COUNCIL ASSESSMENT REPORT

Panel Reference	2017SCL050
DA Number	359/2017/1
LGA	Woollahra Council
Proposed Development	Demolition of existing structures and construction of a seven storey mixed use development containing 39 residential units (5 x studios, 12 x 1 bed, 18 x 2 bed & 4 x 3 bed), 3 ground level retail spaces (proposed hours of 6am-10pm Mon-Sat and 7am-10pm Sun) with ground level parking (9 cars) and a basement car park accessed by a car lift (24 cars) and the removal of a tree at the rear of 28 Bay Street. The proposal also includes a Voluntary Planning Agreement (VPA) with an offer of \$500,000 for projects identified in Council's Double Bay Public Domain Strategy
Street Address	30-36 Bay Street & 2 Guilfoyle Avenue Double Bay
Applicant/Owner	Anka Double Bay Pty Ltd
Date of DA lodgement	04/08/2017
Number of Submissions	87 (46 For and 41 Against)
Recommendation	Refusal
Regional Development Criteria (Schedule 4A of the EP&A Act)	Capital Investment Value of \$24,441,098.00

DEVELOPMENT APPLICATION ASSESSMENT REPORT

PANEL REFERENCE No.	2017SCL050
FILE No.	DA359/2017/1
COUNCIL WARD	Cooper
ZONING	B2 Local Centre
ADDRESS	30-36 Bay Street & 2 Guilfoyle Avenue DOUBLE BAY
PROPOS

A comparative 3D perspective of the development within the context of its surrounds and the heights of existing surrounding developments is as follows:

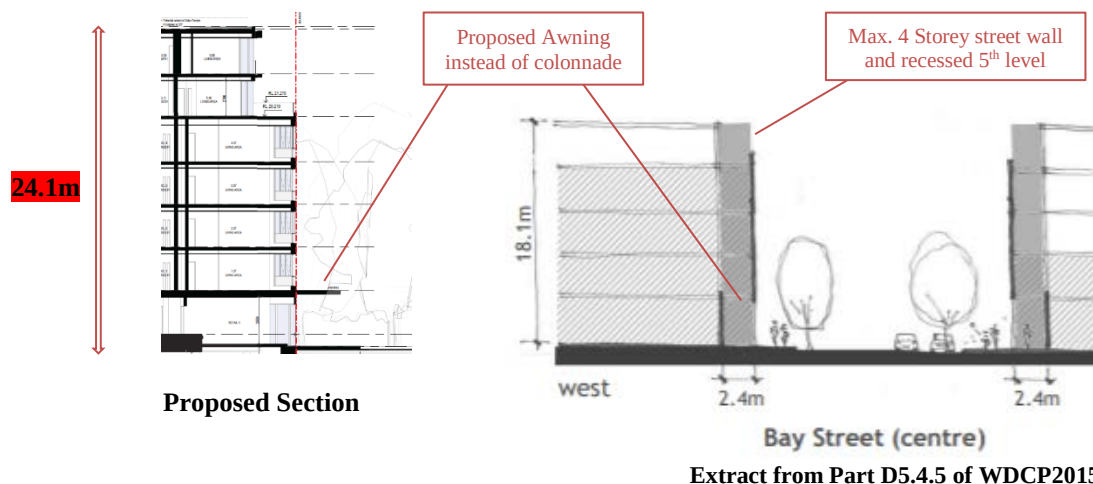
The proposal excessively exceeds the Height of Buildings and Floor Space Ratio development standards prescribed by Woollahra Local Environmental Plan 2014 (WLEP). It inevitably results in a building envelope that exceeds the site specific envelope controls prescribed by the Woollahra Development Control Plan 2015 (WDCP). One of the key objectives of this DCP states "...To ensure new development is compatible with the existing built form, streetscape and village character."

The WDCP also provides a desired future character for Bay Street (Centre) which focuses on Guilfoyle Park which is defined by the surrounding buildings. The WDCP states: “...*Expand the public domain at street level and improve civic character with street level colonnades ...Provide a built form that responds to the scale and civic importance of Guilfoyle Park ...Higher buildings are permitted ...to provide appropriate definition of the space.*”

The proposal does not satisfy the WDCP’s stated key objective or the desired future character for this locality. It also does not provide a satisfactory contextual transition to the low scale residential zone immediately adjoining to the south and west.

(Objectors Photo from West facing balcony 5A/2-22 Knox Street)

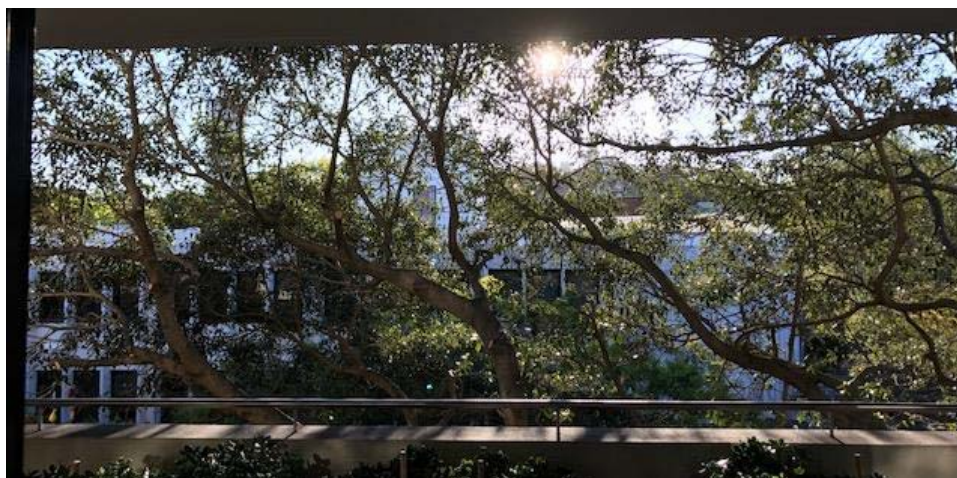
From No.2-22 Knox Street, the units are afforded views from windows and balconies to the west with a gauge on the type of views as follows:

The second question posed by the Court relates to whether a more skilful design could provide the same development potential whilst reducing the impact on views. As stated earlier, the view loss is caused by a building that is excessive in its height and scale and is a result of the non-compliances with the site specific envelope controls prescribed by the WDCP.
